# CITY OF TAMPA

## ADDENDUM 1

**DATE: November 3, 2017**

Contract 17-C-00031; Howard F. Curren AWTP Screen and Grit Building 2 Grit Washer Replacement

HOWARD F. CURREN AWTP SCREEN AND GRIT BUILDING 2 GRIT WASHER REPLACEMENTS  
 GRIT UNIT ELECTRICAL LOWER PLAN

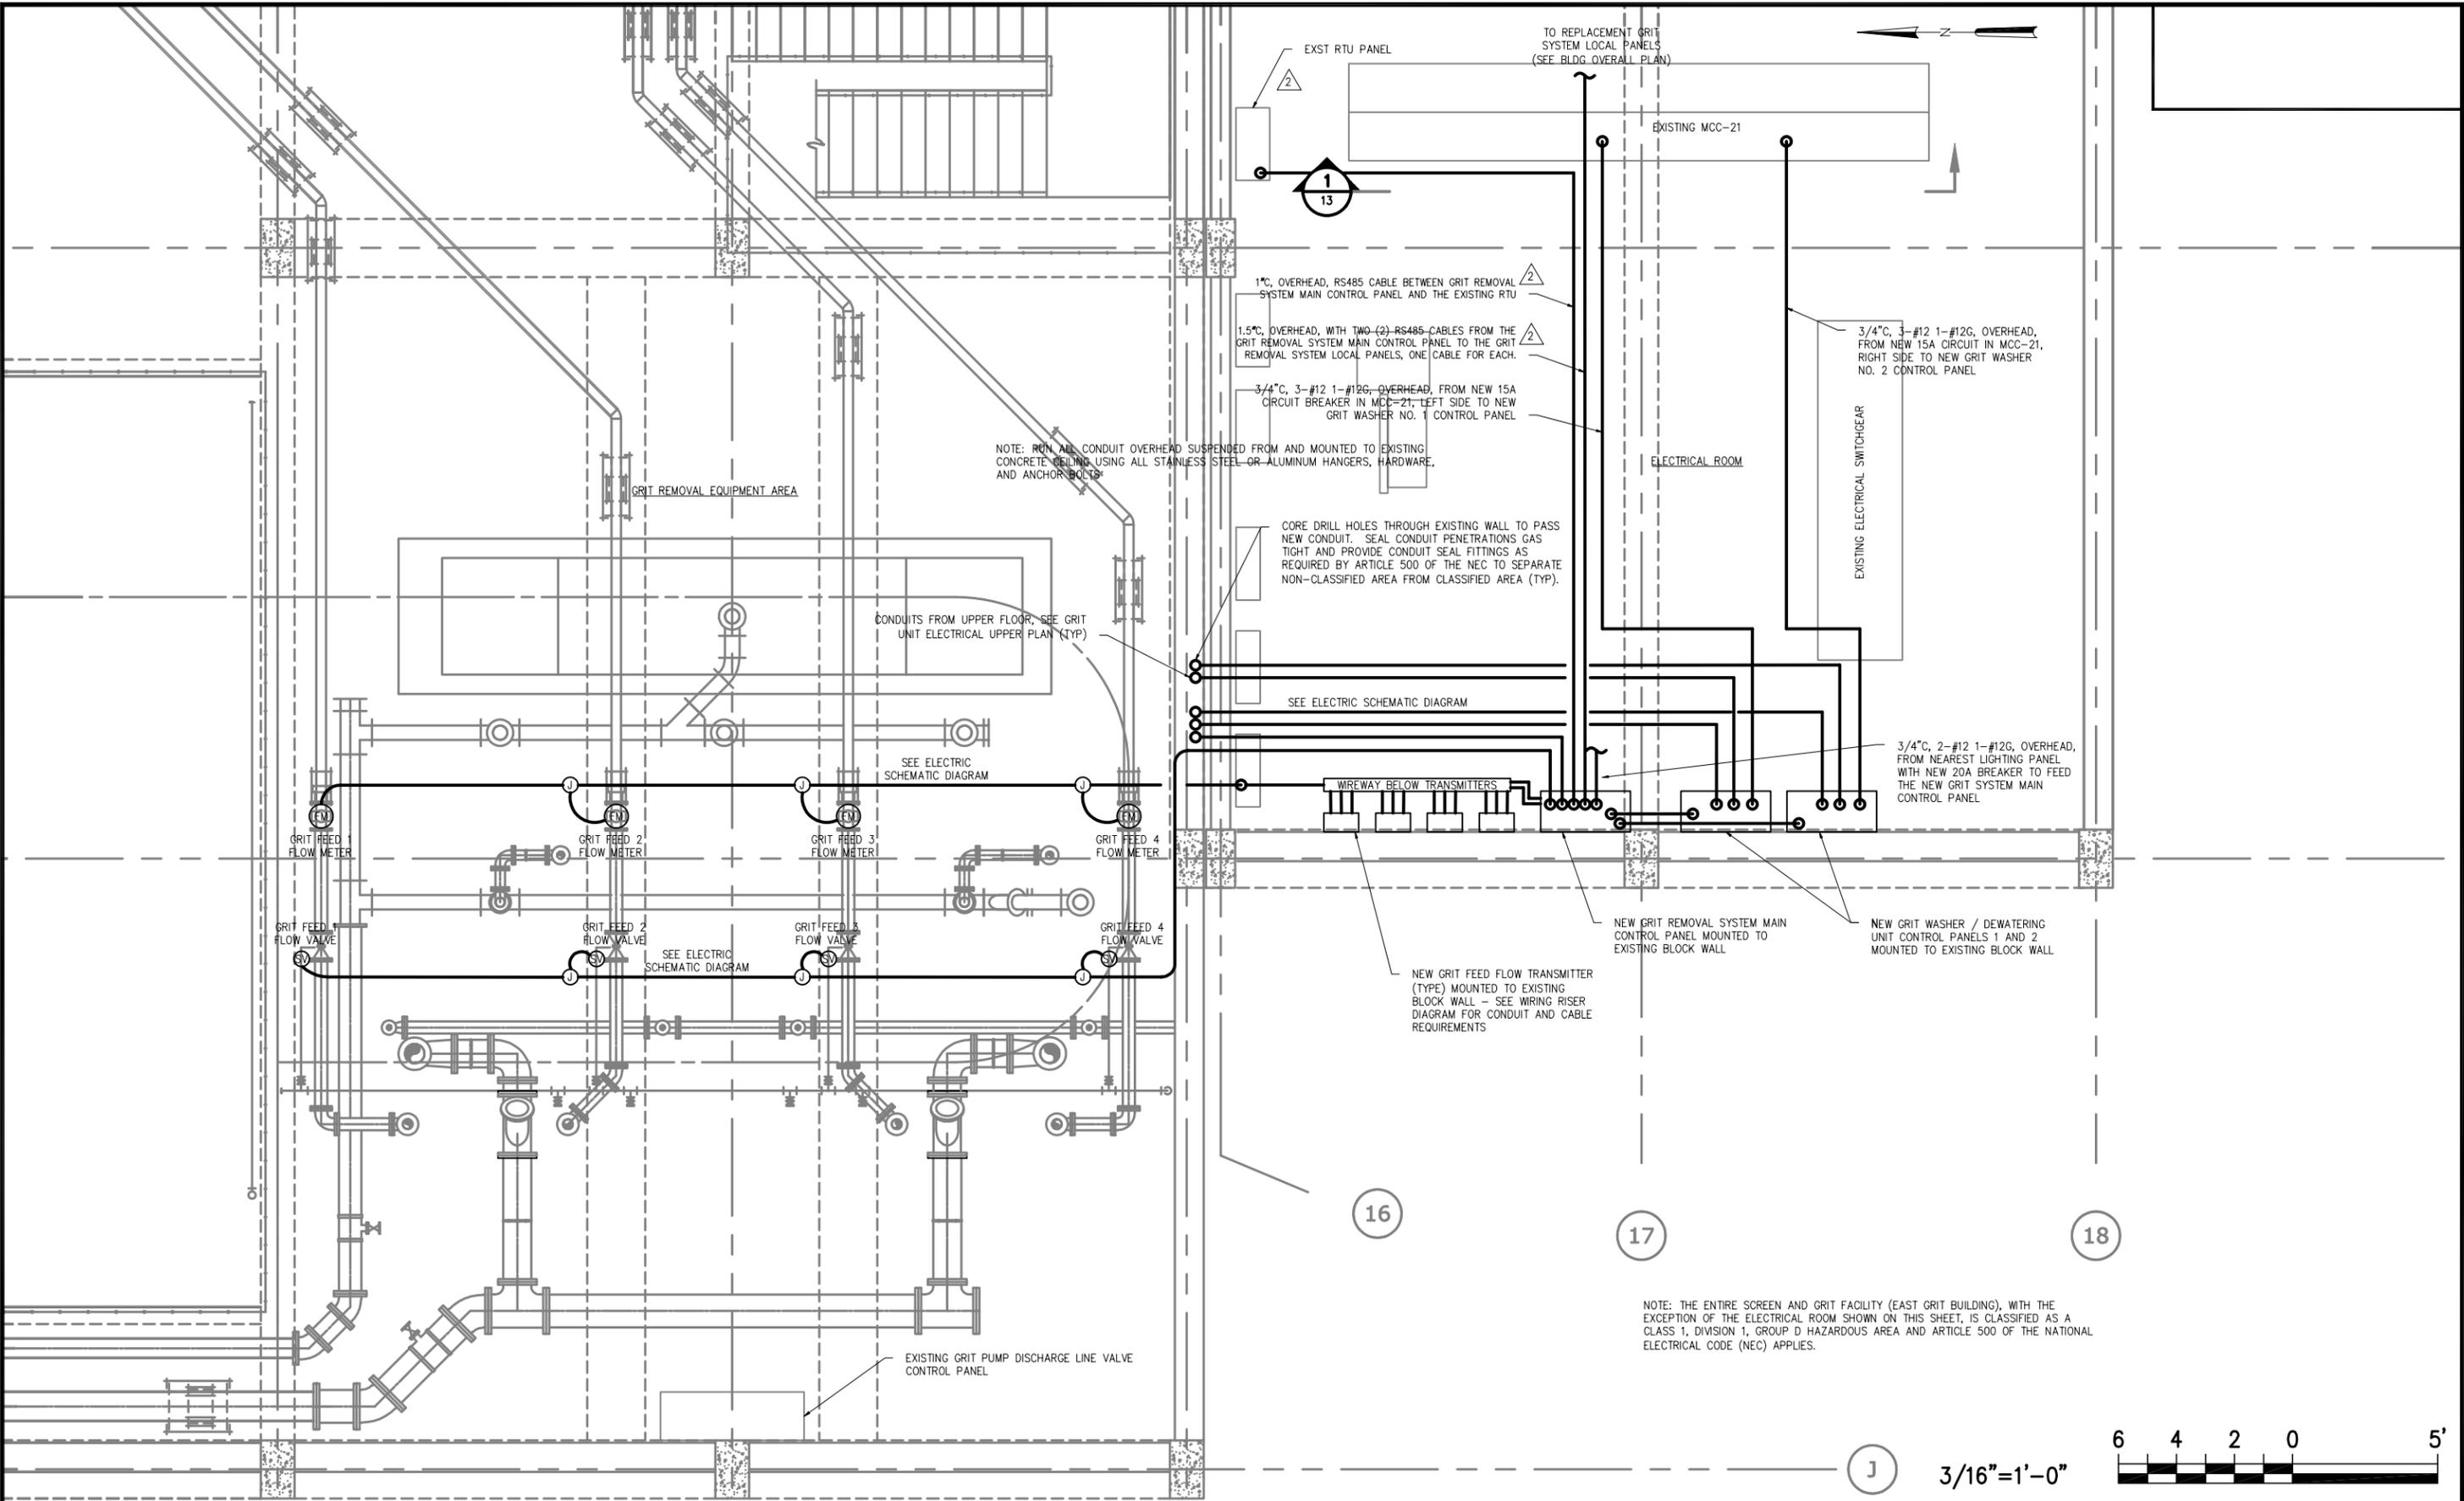
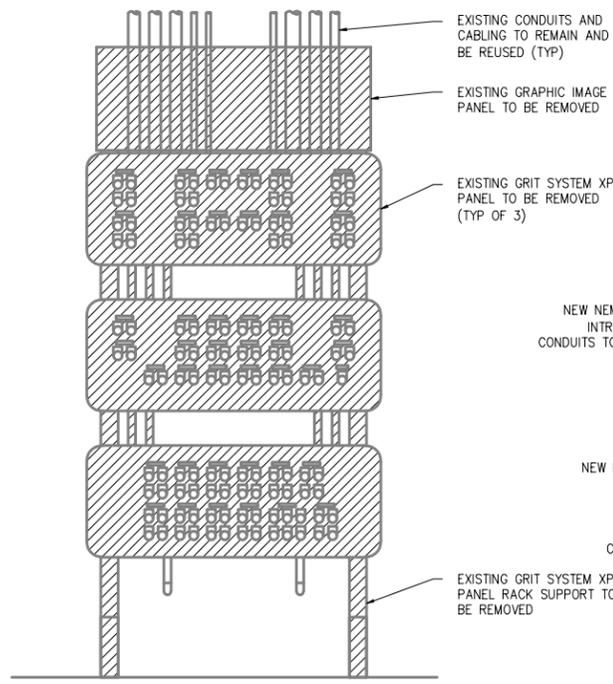
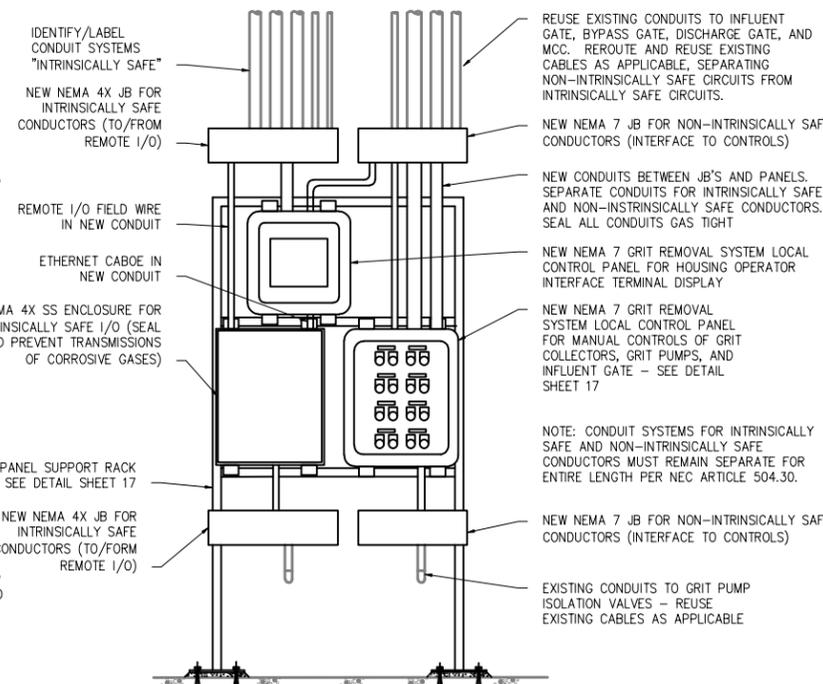
Item 6: Replace Plan Sheet 14 Grit Unit Electrical Lower Plan with the attached Plan Sheet 14.

GRIT REMOVAL SYSTEM CONTROL PANEL, CONDUIT, AND WIRING SCHEMATIC DIAGRAM

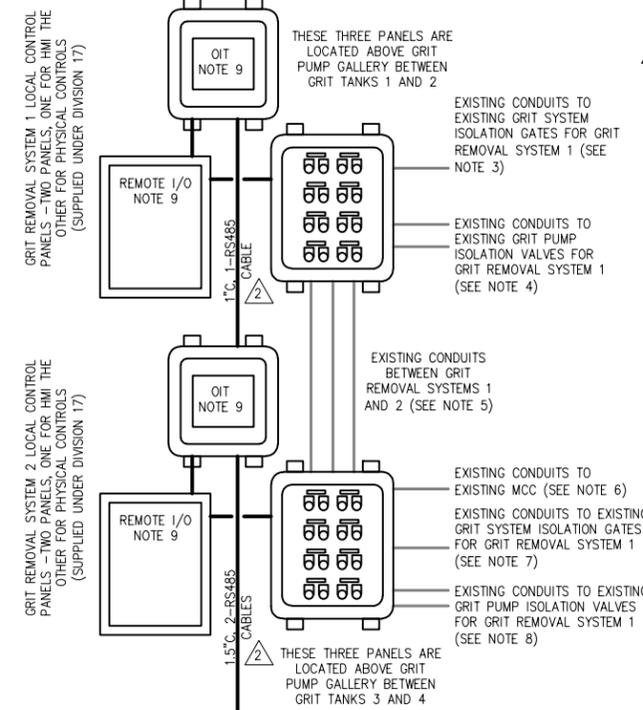
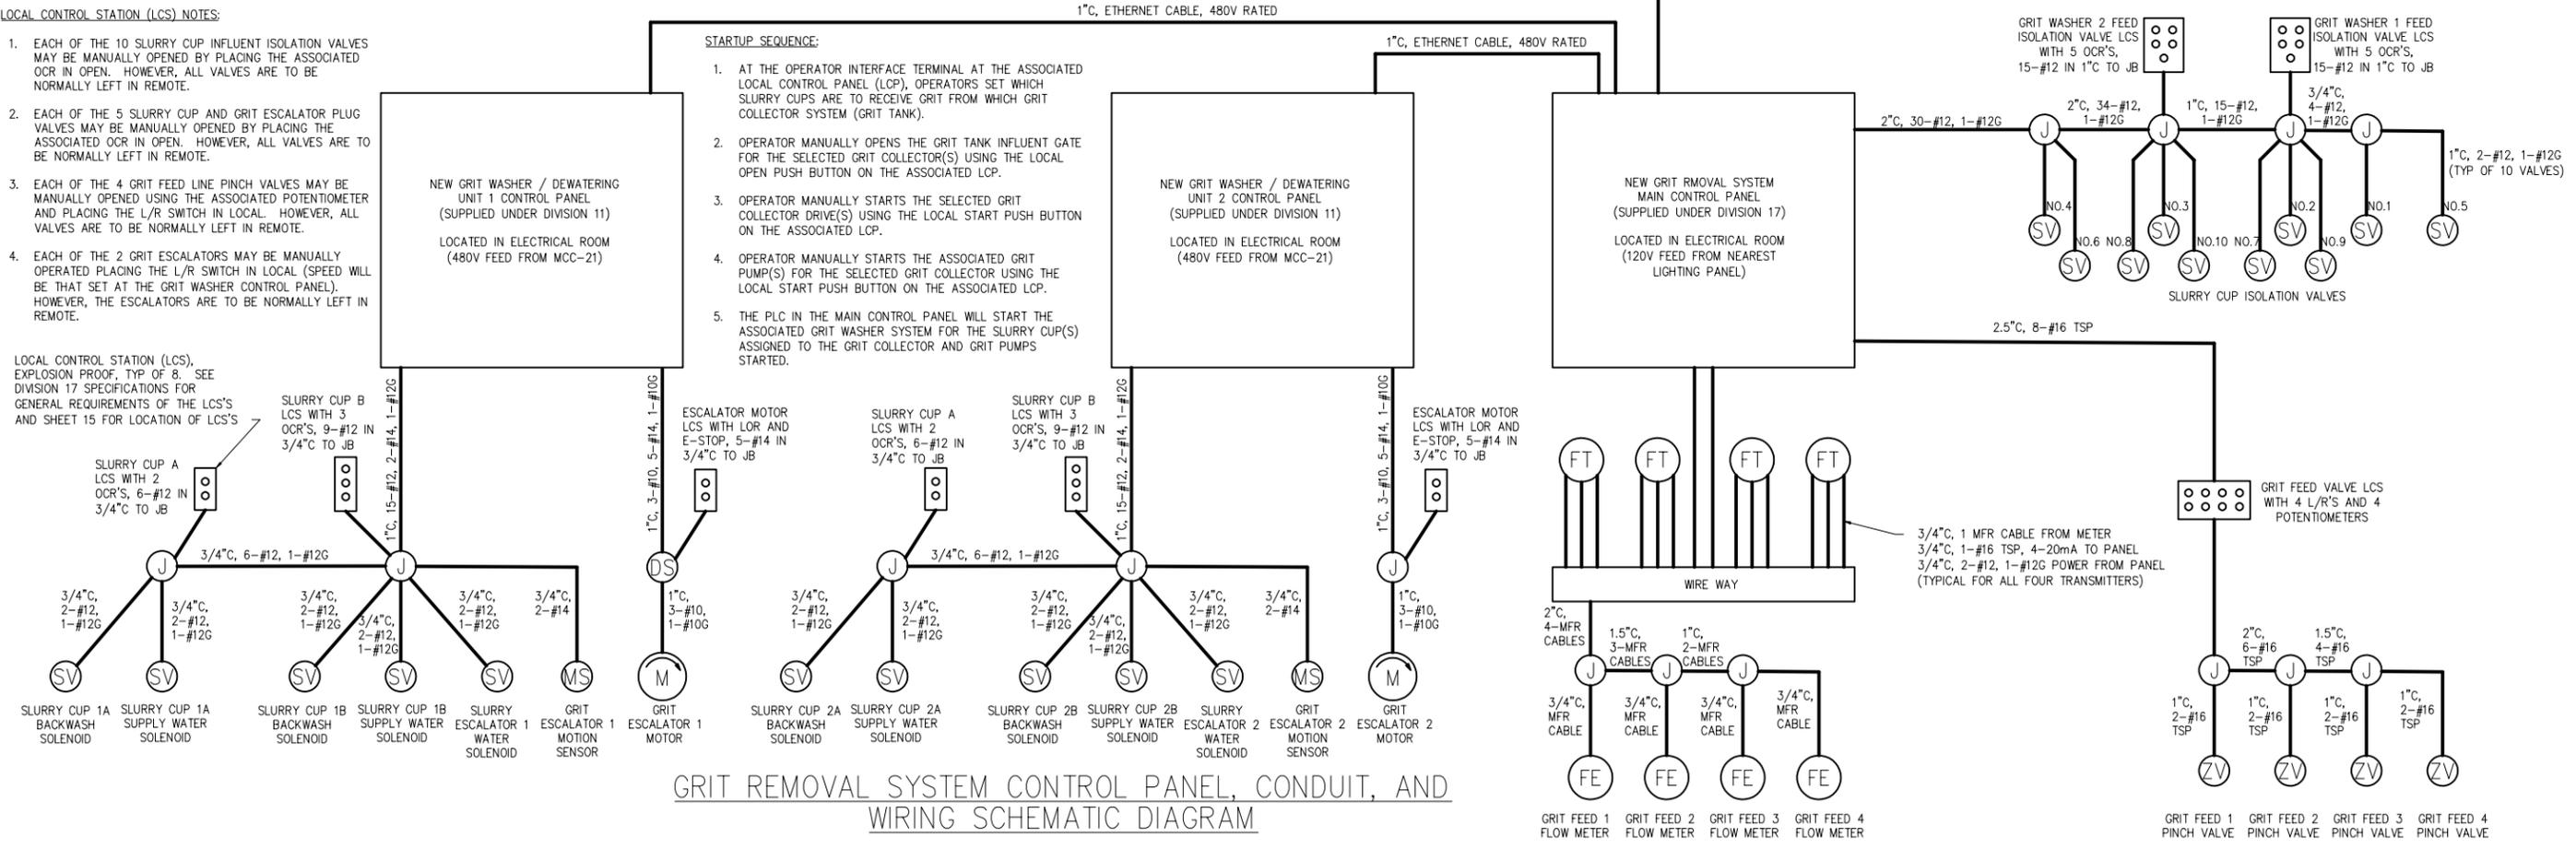
Item 7: Replace Plan Sheet 16 Electrical Schematic Diagram with the attached Plan Sheet 16.
